BOARD ACTION REPORT – APPEALABLE ITEM

Project Name: Khalil & Adam's Residence
Project Location: 797 Andrews Avenue
Request: Class III Site Plan Modification

---STAFF REPORT---

797 Andrews Avenue – Class III Site Plan Modification, Landscape Plan and Architectural Elevations associated with a first and second floor expansion and a garage addition to an existing residence part of a four unit (4) residential complex. The subject property is located on the southeast corner of George Bush Blvd. and Andrews Avenue.

LANDSCAPE PLAN — MODIFIED

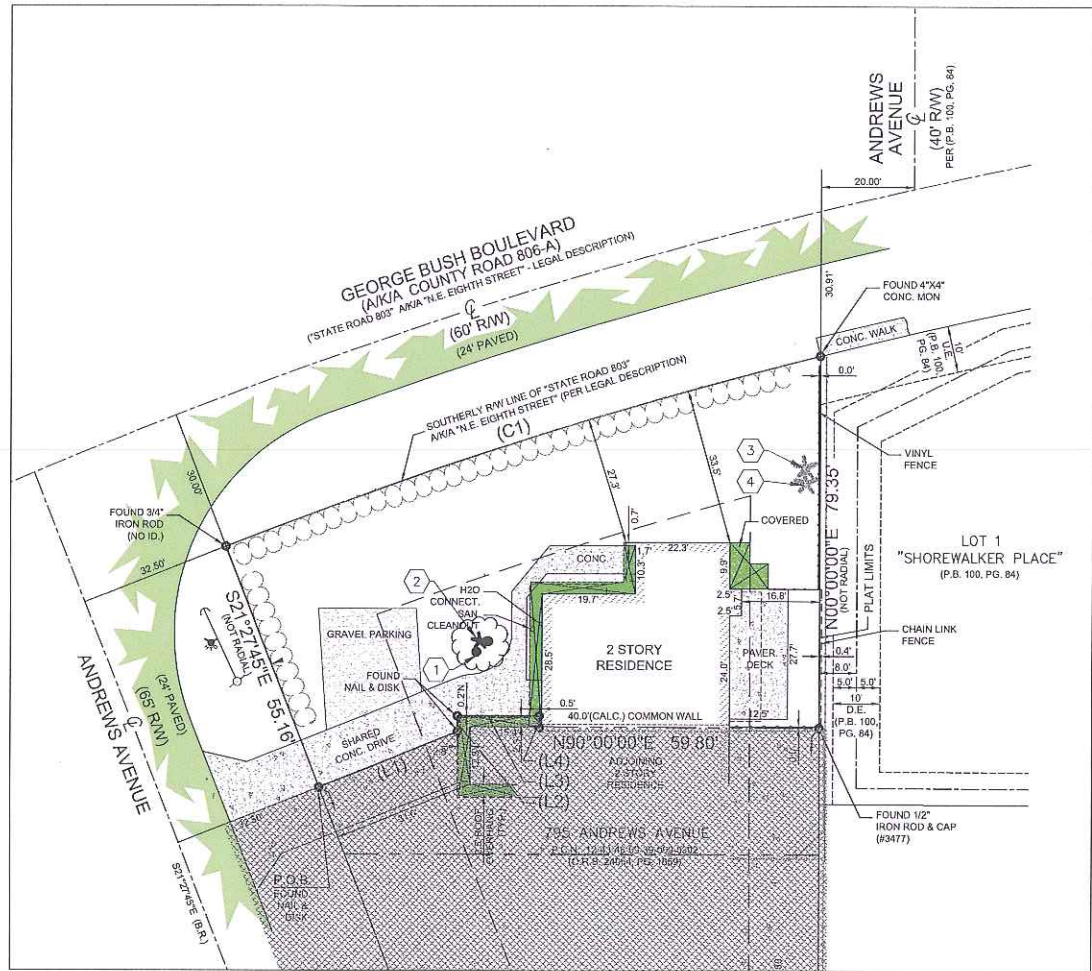
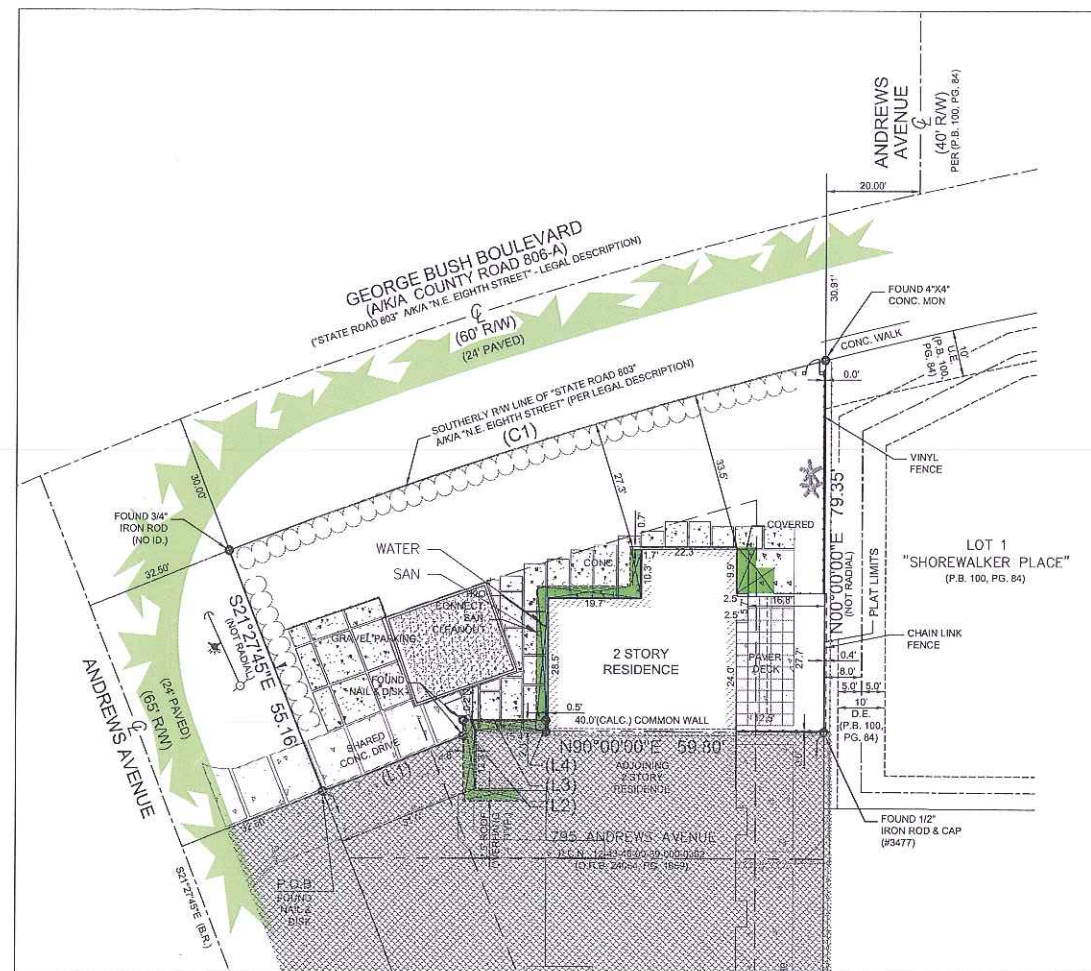
The proposed Class III Site Plan Modification contains the removal of two trees including a strangler fig (ficus aurea), located on the northwest side of the property and rated at 50% condition, and a sabal palm (sabal palmetto) growing in the strangler fig and assessed in good condition. The removal of these two trees is required as they are located within the footprint of

the proposed garage. The landscape plan has been reviewed by the Senior Landscape Planner and has been found to be in compliance with applicable requirements of LDR Section 4.6.16, provided that the condition of approval is addressed as follows:

1. Two additional trees will need to be added to the property to mitigate for the removal of the two trees, if approval is granted. Mitigation plan must include two shade trees at a minimum of twelve (12) feet in overall height at the time of planting, with a minimum of four (4) feet of single straight trunk with six (6) feet of clear trunk, and a six (6) foot spread of canopy. All trees must be installed prior to the final landscape inspection.

1. Two additional trees will need to be added to the property to mitigate for the removal of the two trees. Mitigation plan must include two shade trees at a minimum of twelve (12) feet in overall height at the time of planting, with a minimum of four (4) feet of single straight trunk with six (6) feet of clear trunk, and a six (6) foot spread of canopy. All trees must be installed prior to the final landscape inspection. Mitigation plan to be reviewed and approved by the City Landscape Planner prior to certification.
